Access Compliance Report Public Rights-of-Way (Curb Ramps)

Main Street: ANTONIO_PKWY Cross Street: CROWN_VALLEY_PKWY Location: NE

ADA ID: RPRK211101112432 Ramp Type: Type 1 - Perpendicular Diagonal Initial Pass/Fail: Pass Overall Compliance: No Severity Score: 16

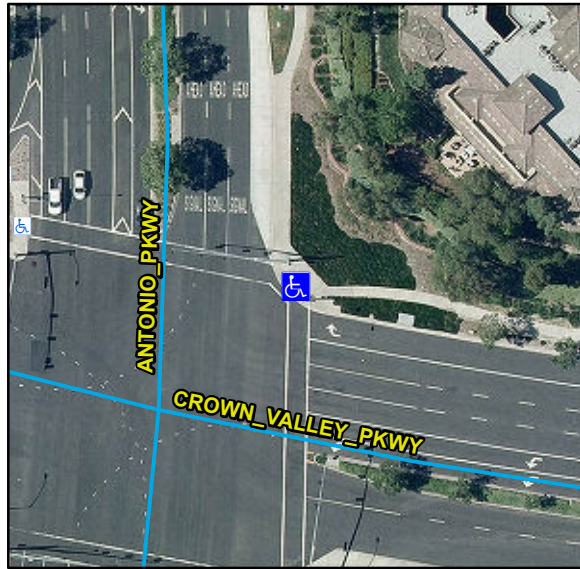
Install Detectable Warning System. Remove & Replace Gutter.

R305, R304.5.4, STD 1115
